IAE Propulsion System NON-MODIFICATION SERVICE BULLETIN

Subject: Transmittal of Revision 3 to Service Bulletin
No.V2500-ENG-72-0356

To relax the requirement for replacement of Service Bulletin V2500-ENG-72-0362 High Strength Bolts at the ultrasonic inspection and visual inspection.

ENGINE - LP COMPRESSOR- INSPECTION CHECK OF INSTALLED ANNULUS FILLERS
(NON-MODIFICATION)

Location of Annulus Fillers
Figure 1 (Sheet 1 of 2)

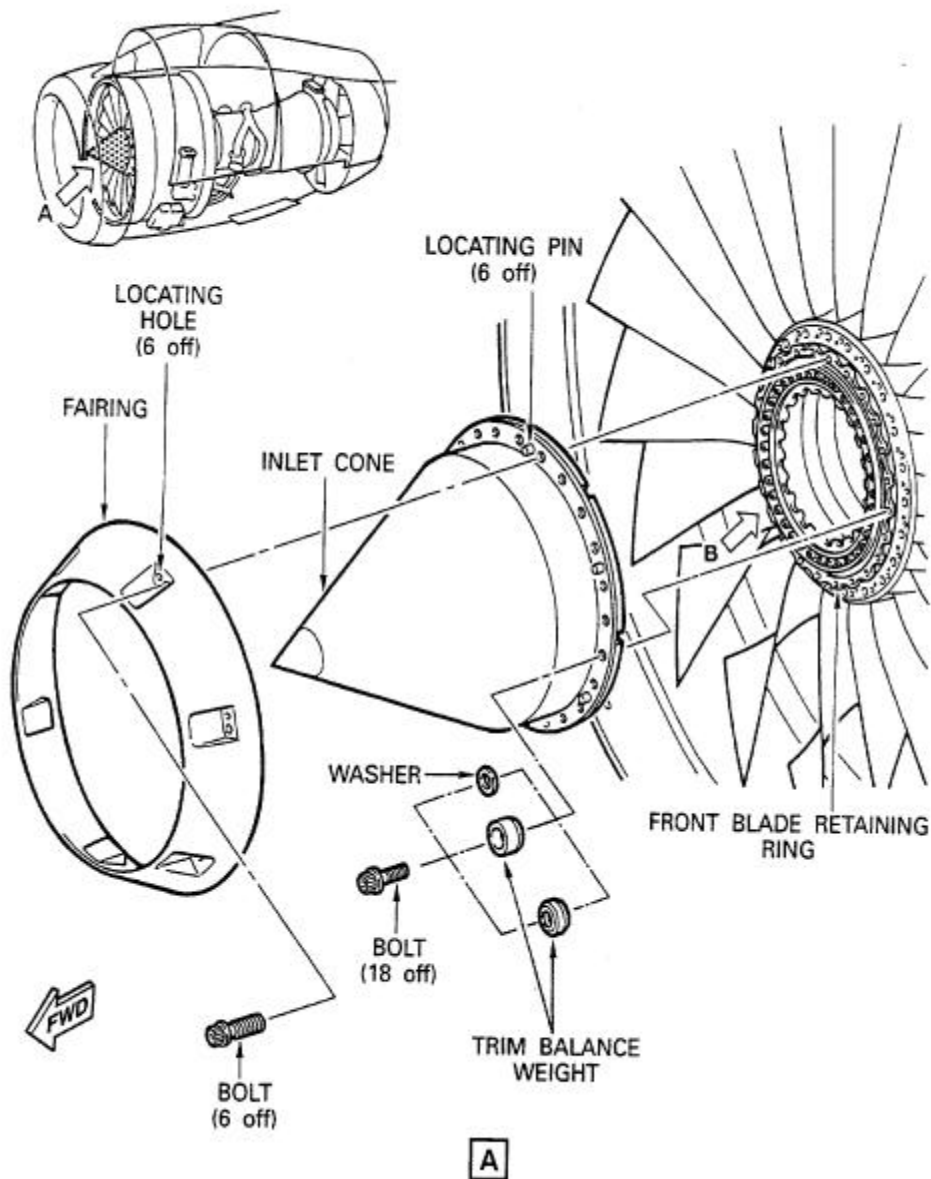
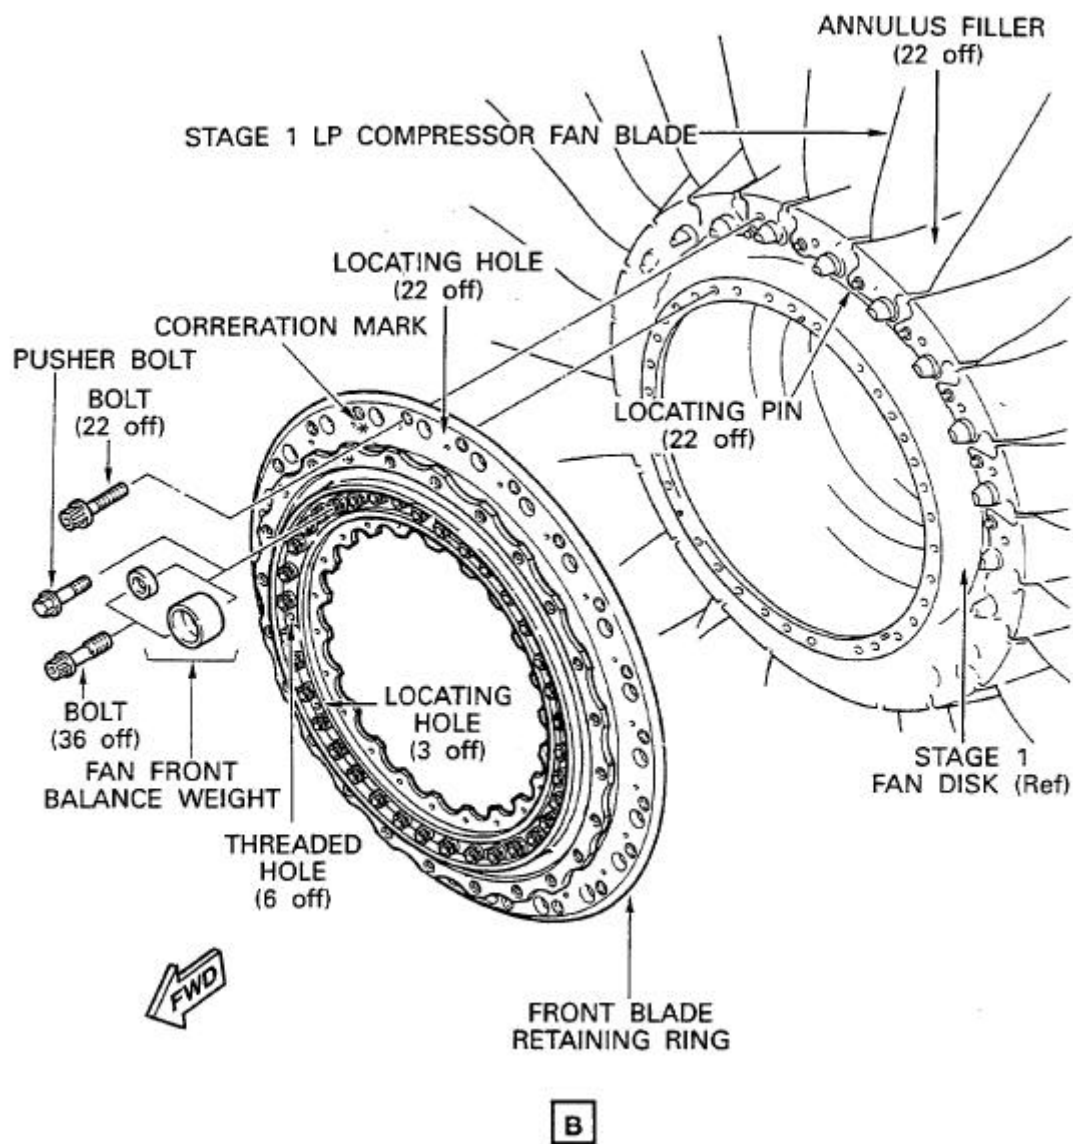
- (a) Remove the Inlet Cone Fairing, Inlet Cone, Trim Balance Weights and Fan Blade Front Retaining Ring to gain access to the Annulus Fillers as shown in Figure 1. (Refer to the A320 Aircraft Maintenance Manual (AMM), Chapter/Section, 72-38-11, Removal/Installation and 72-31-11 Removal/Installation (for in service) or refer to the A1 Engine Manual (EM), Chapter/Section 72-38-11, Disassembly and 72-31-00, Disassembly (for in shop)).

Probe Position on Test Block for Calibration
Figure 2

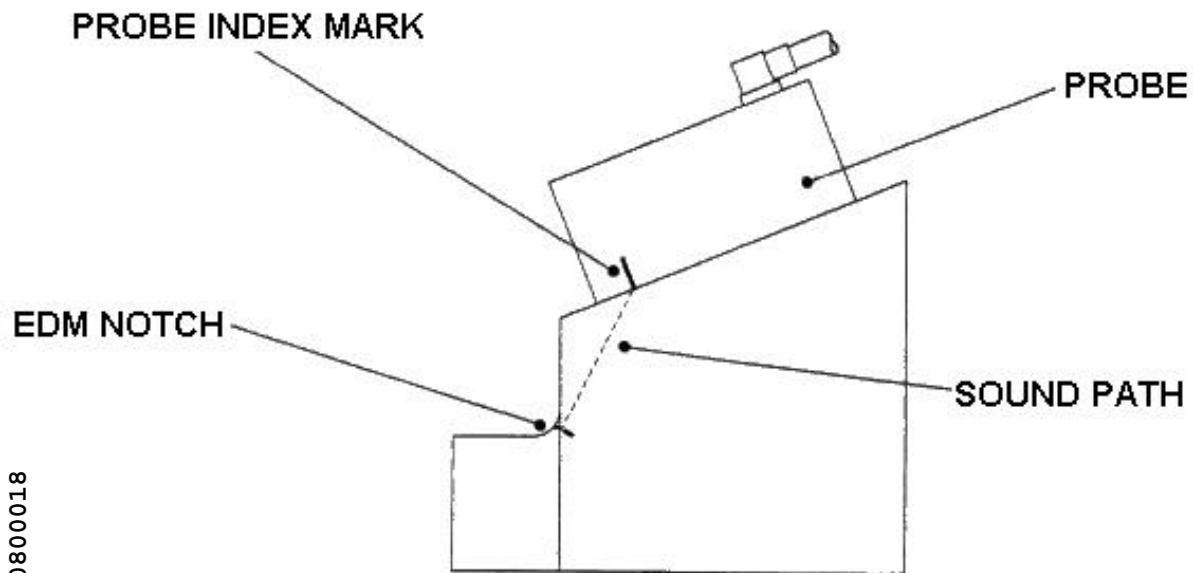
- (i) Ensure Flaw Detector is set to pulse echo mode.
- (ii) Turn time base delay control to zero.
- (iii) Connect Probe (IAE 2R19440) to Flaw Detector.
- (iv) Apply Couplant to Test Block and position Probe on Test Block (IAE 2R19441) as shown in Figure 2.
- (v) Identify and maximize the signal reflected from the EDM notch in the lug radius and with the time base range control, position the signal at the 5 division mark on the time base. Adjust the Signal Amplitude to full screen height.

Probe Position on Annulus Filler Upper Surface for Inspection
Figure 3

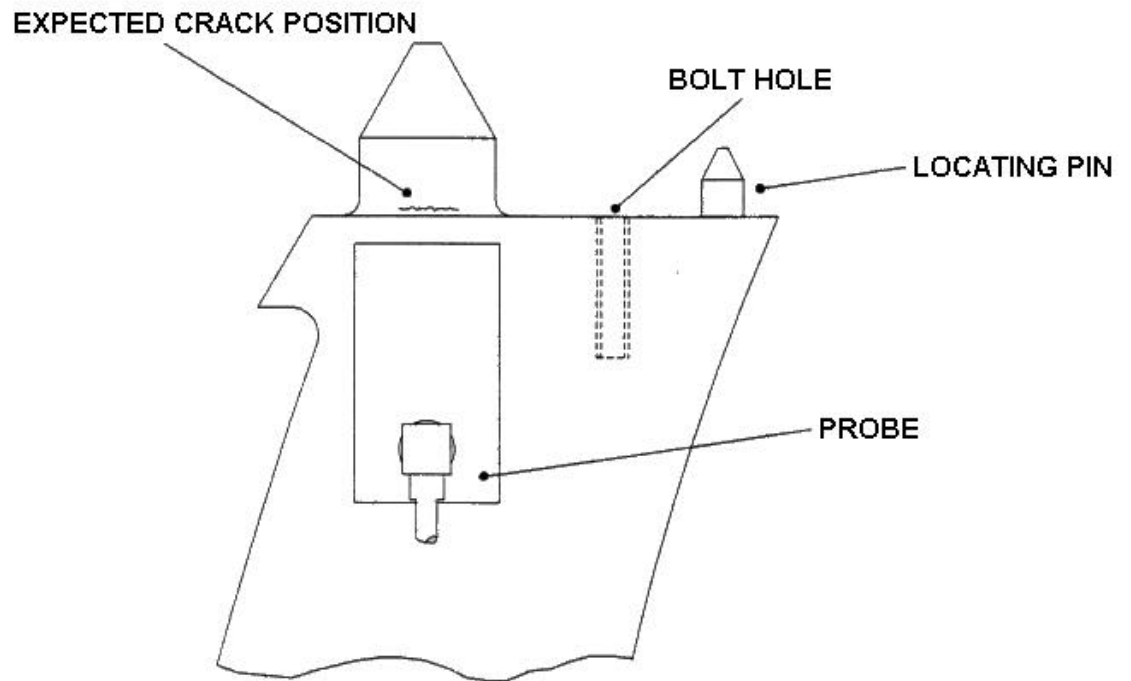
- (i) Clean Annulus Filler to remove any surface dirt, oil or grease. Refer to Figure 1.
- (ii) Apply Couplant to the Annulus Filler and position the Probe as shown in Figure 3. The Probe should be positioned on the extended center line of the lug which is approximately 0.67 inch (17 mm) from the Fan Blade leading edge radius on the Filler. The front of the Probe should be approximately 0.20 inch (5 mm) from the front edge of the Filler.
- (iii) Move the Probe a small amount from side to side, backwards and forwards and maximize any signal seen.
